WBC Highway Comments

MEMORANDUM

From:	Gordon Adam Development Control		
Service	SDL Highways	App No:	242279
Address:	Land west of Old Wokingham Road and North and South of, Easthampstead Road, Wokingham, (Proposed SDL Extension).		
Proposal:	Outline application with all matters reserved except means of access for up to 180 dwellings and associated infrastructure including open space, play space, landscaping, SuDs and green infrastructure. Please note: The application has been submitted in relation to the area proposed as an extension to the South Wokingham SDL in the Local Plan Update(LPU).		
Type of Development:	Major Dwellings (10+)		
Site Visit Made:	Yes/No

DESIGNERS RESPONSE

Scale 1:500 @ A2	Date FEB 2023	Drawn TDM	Checked NB
Drawing No A218-014	Revision P5

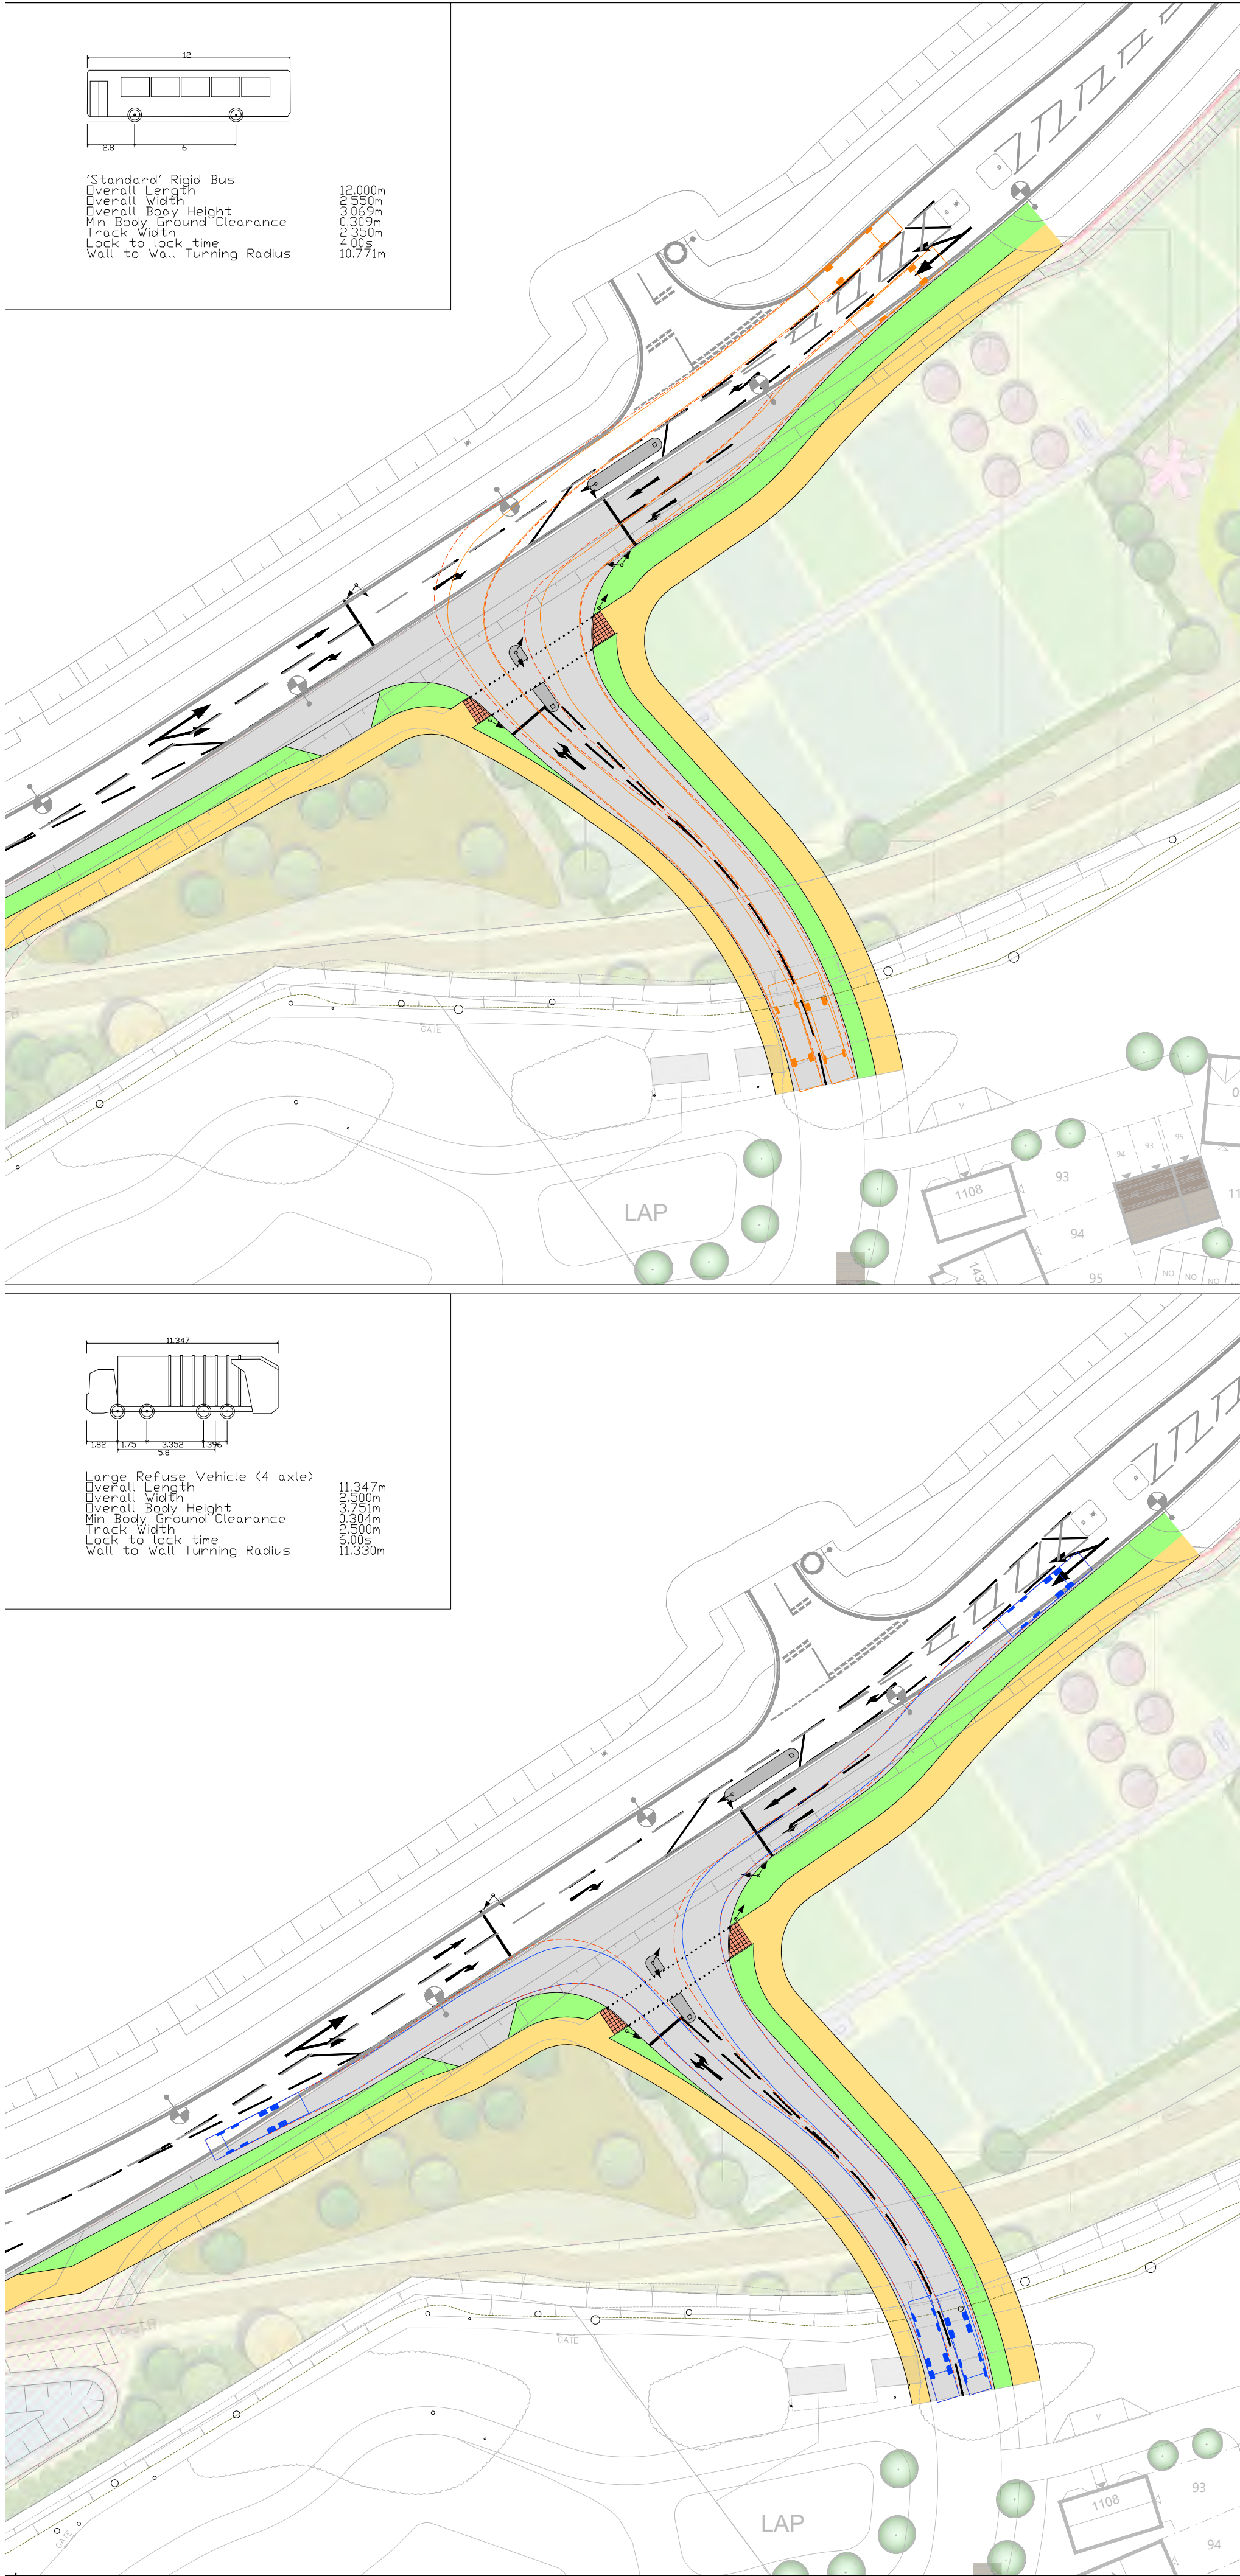
42. Drawing A218-014 Rev P3 has been submitted showing visibility splays of 2.4 x 120m which relates to a 40mph speed limit.
43. Clarification is required on the current speed limit on the road as it appears that the speed limit changes close to the proposed access 60mph to the south and 40mph to the north. Or is there speed reduction to 40mph part of the South Wokingham SDL approval.
44. There appears to be a tree that is within the visibility splay and a further assessment is required on whether or not there would be an impact on the visibility splays.

Drawing No: **A218-019** Revision: **P6**

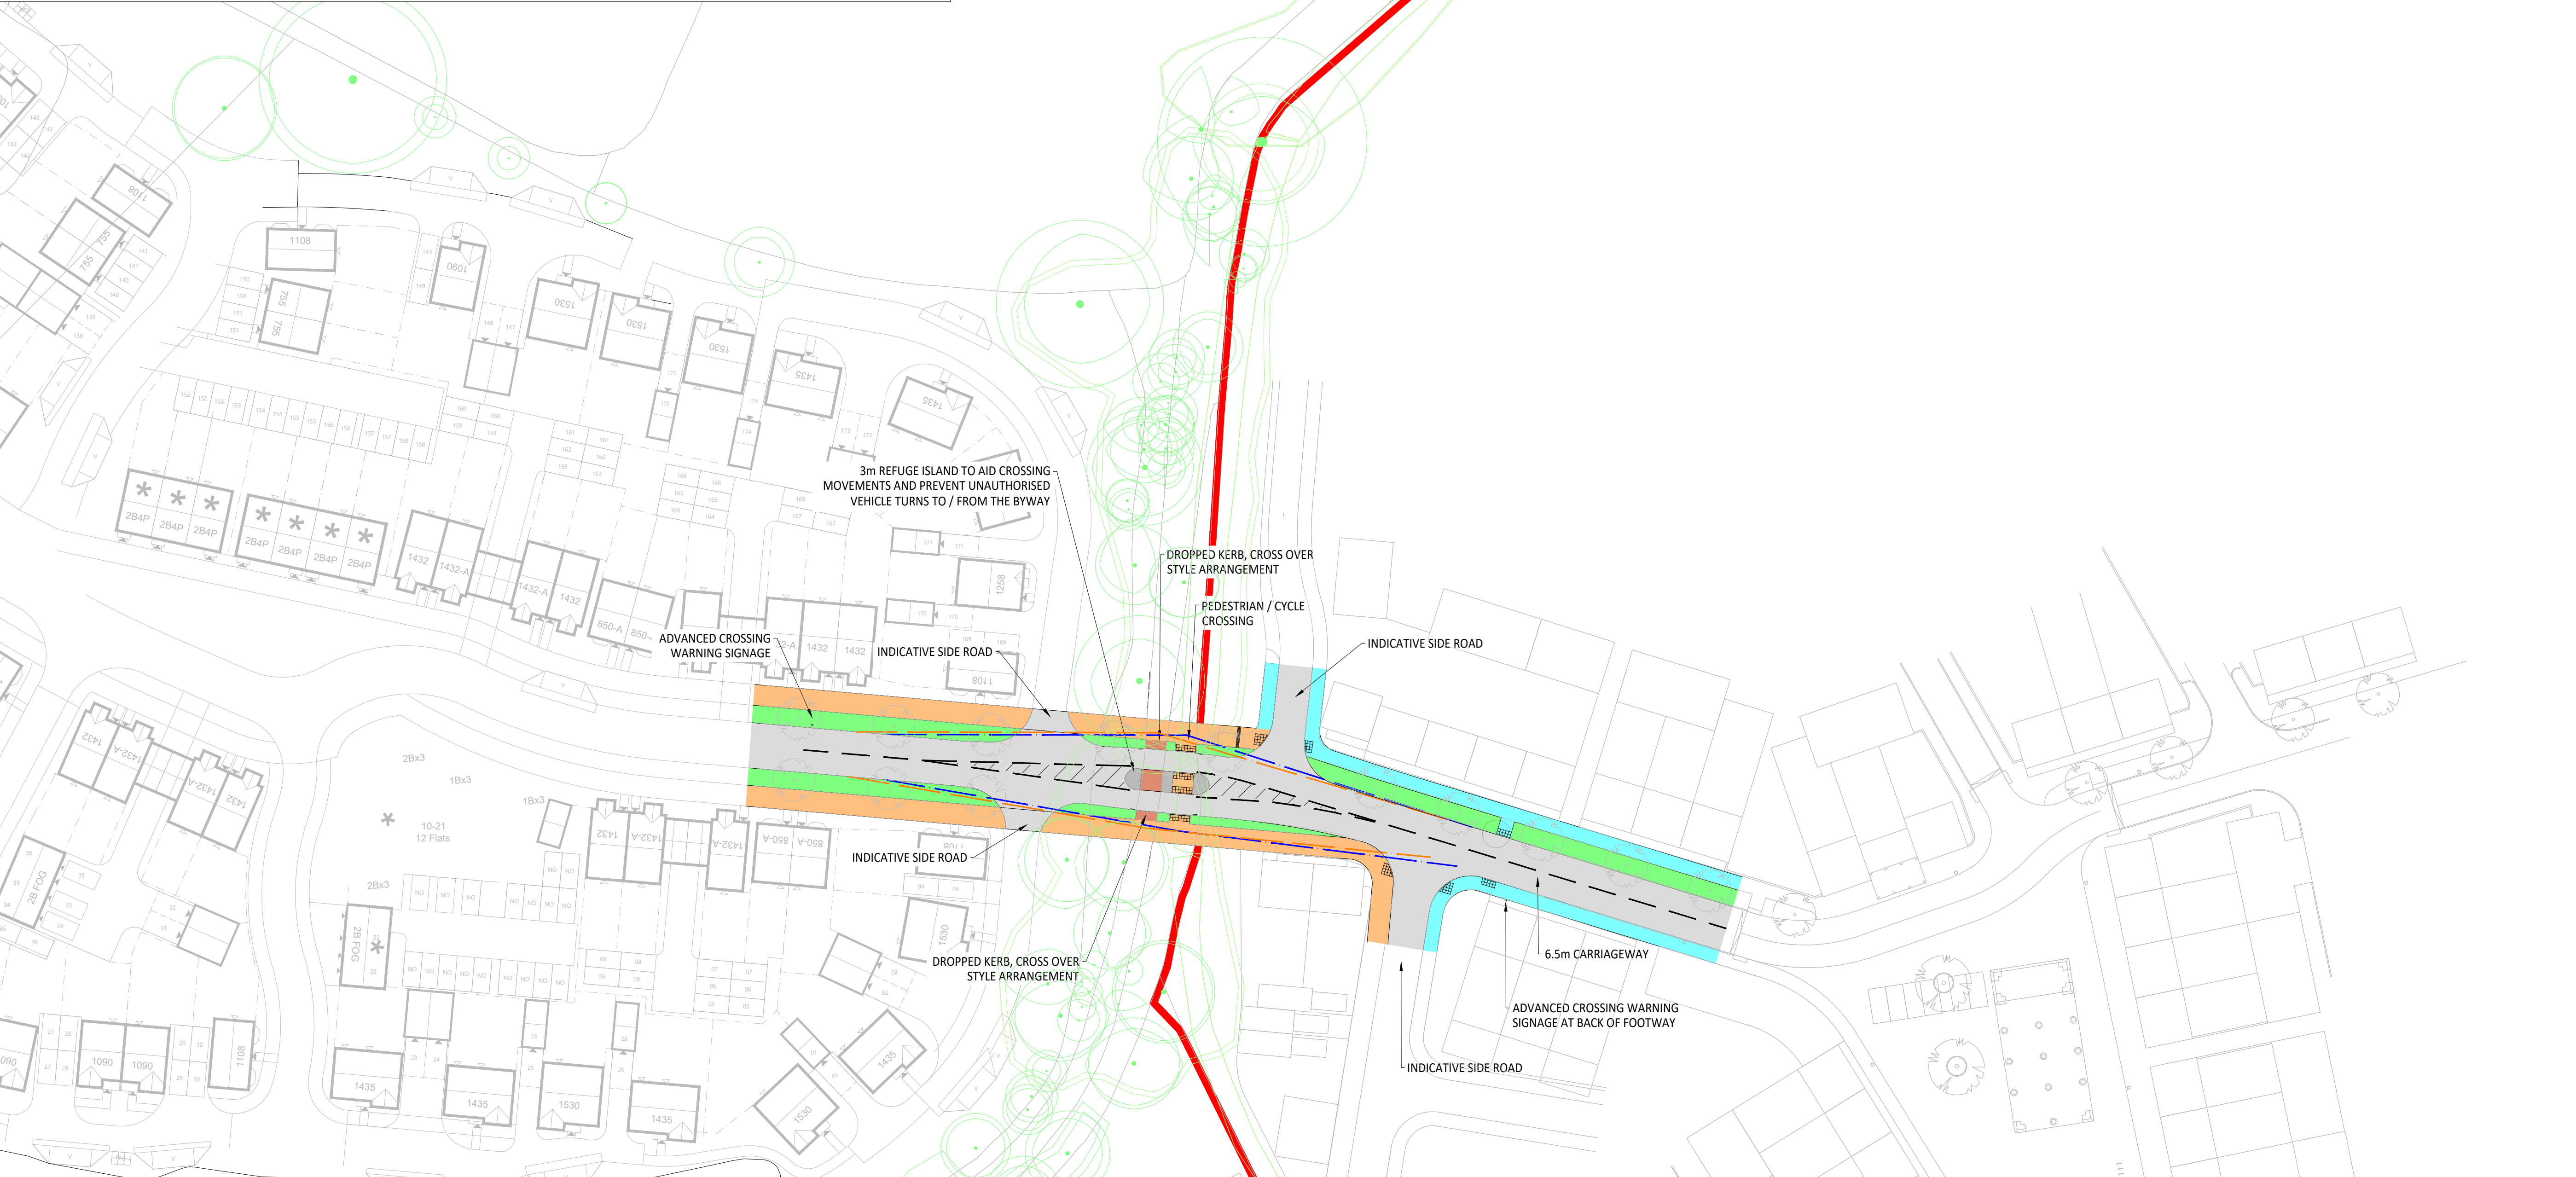
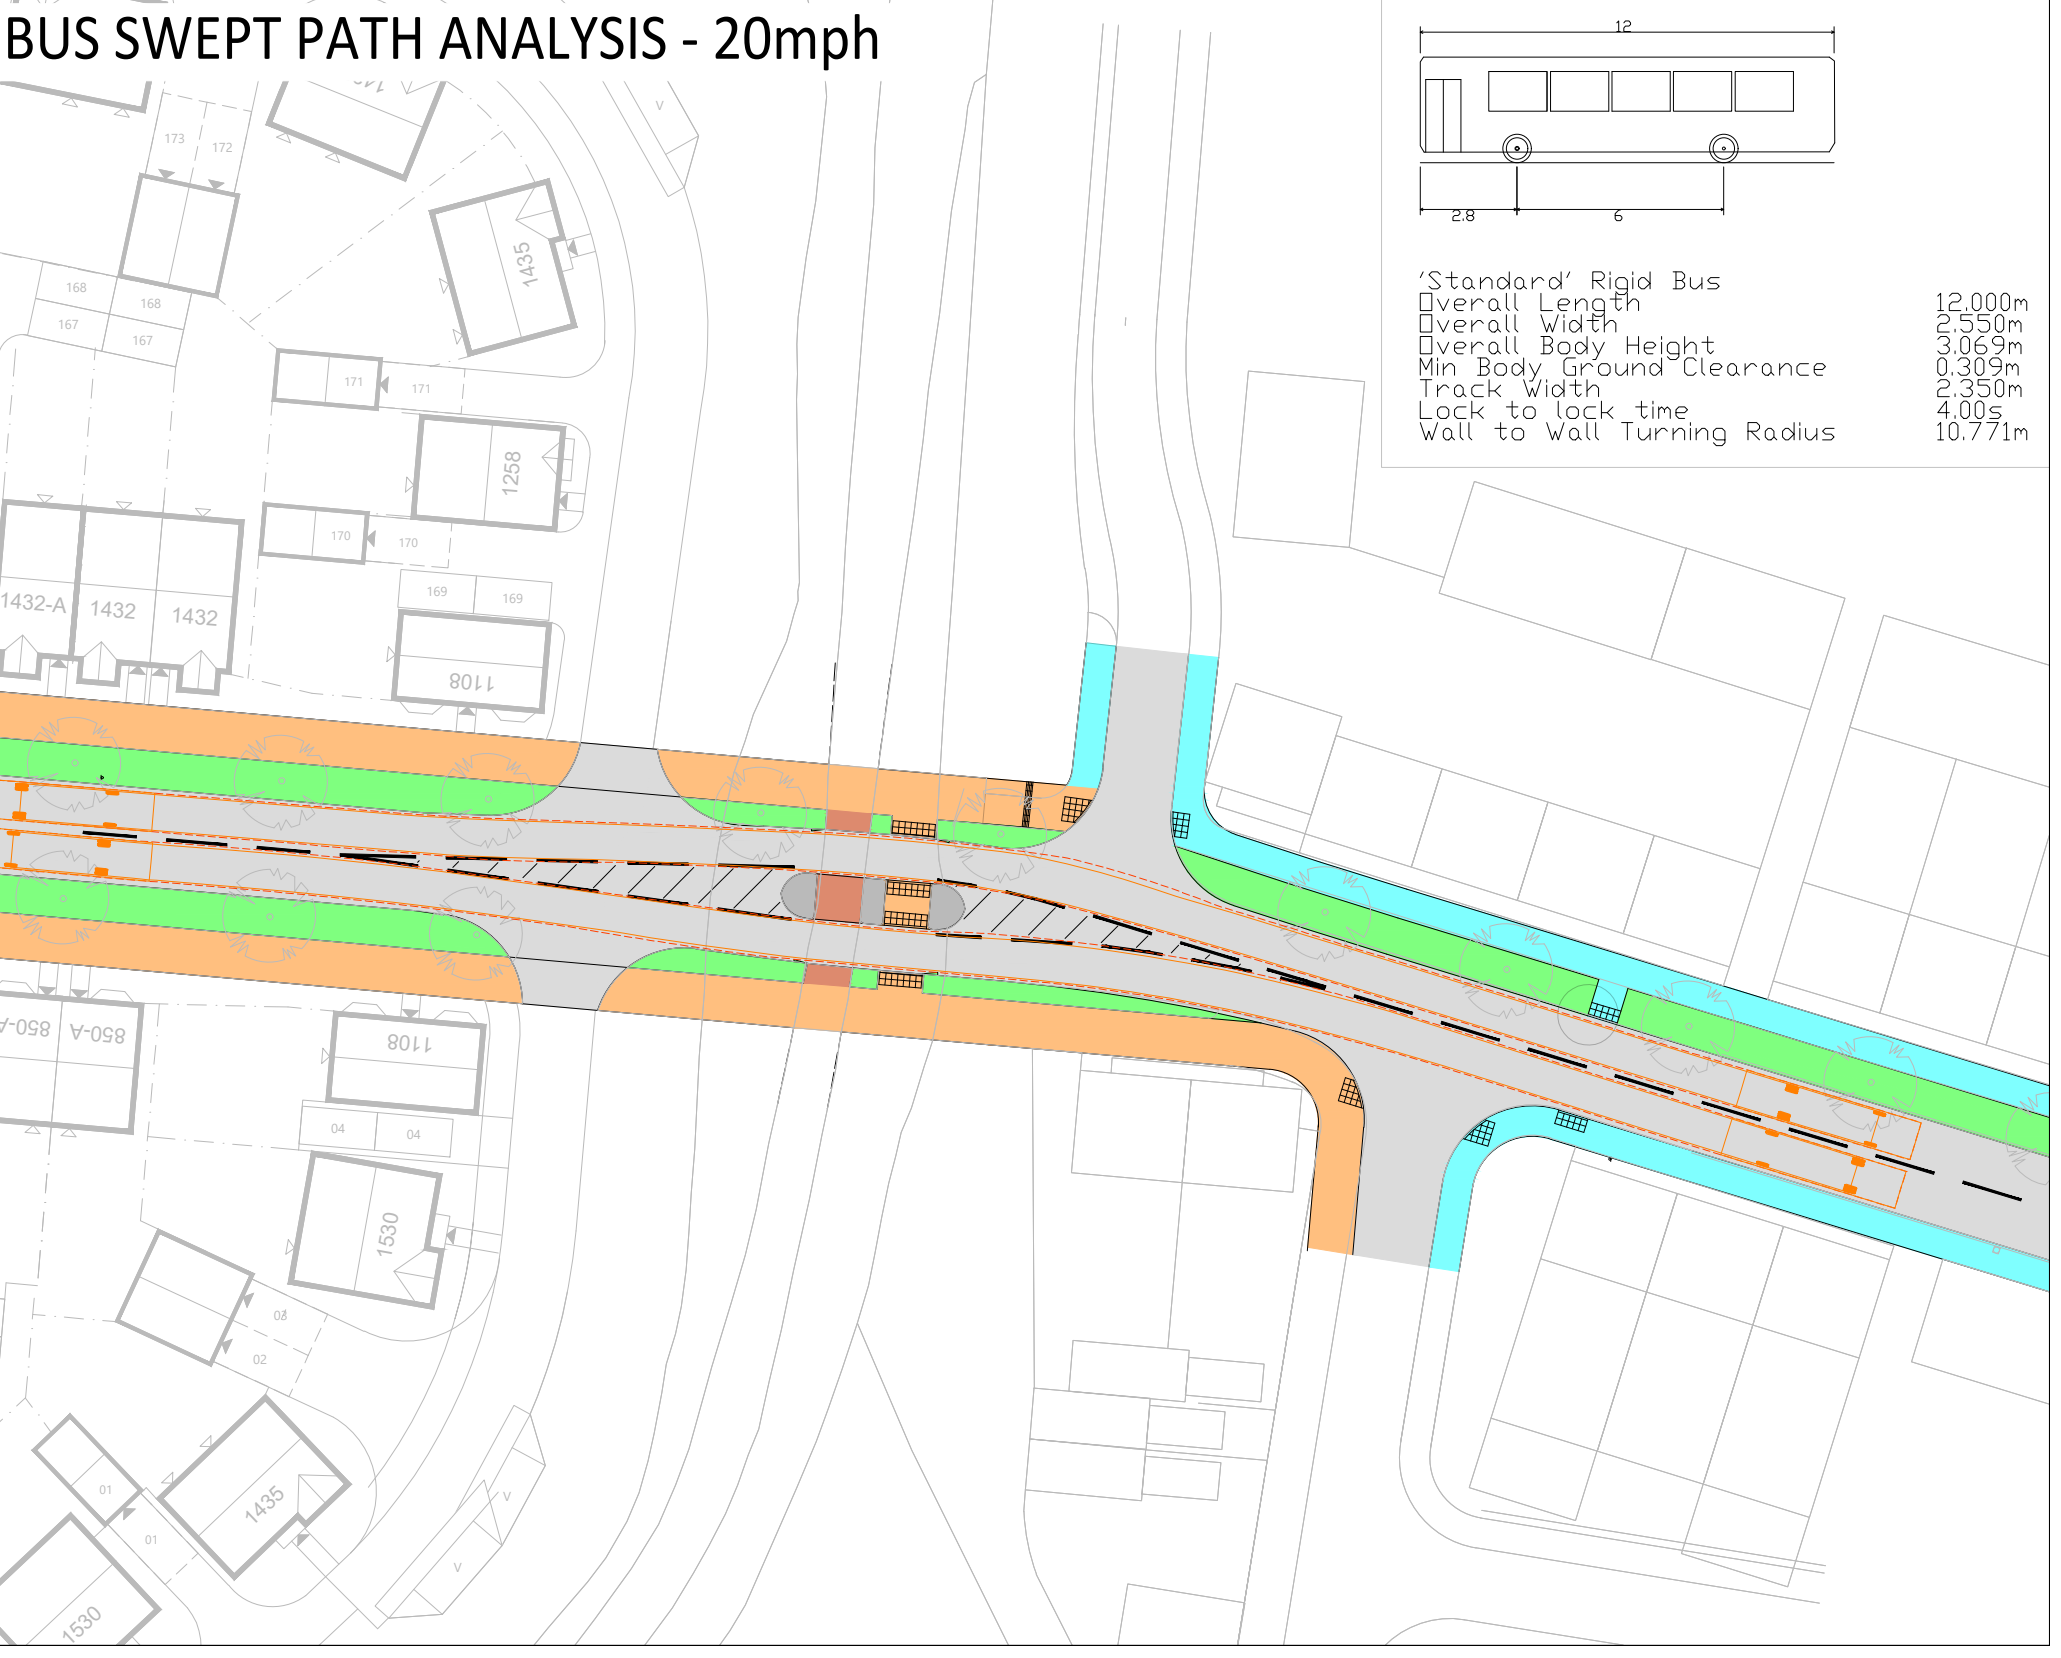
- 2.1.3 Assess the potential desire for pedestrians and/or cyclists to cross the 'main' route at the junction and provide an appropriate facility if deemed necessary.

- 2.3.3 Provide a parking bay for signals maintenance vehicles.

- 2.4.3 Provide illuminated or reflective bollards at either end of the islands.

- 2.6.3 Provide a secondary signal on the central island.

- 2.3.4 *Agreed Maintenance Bay Added*
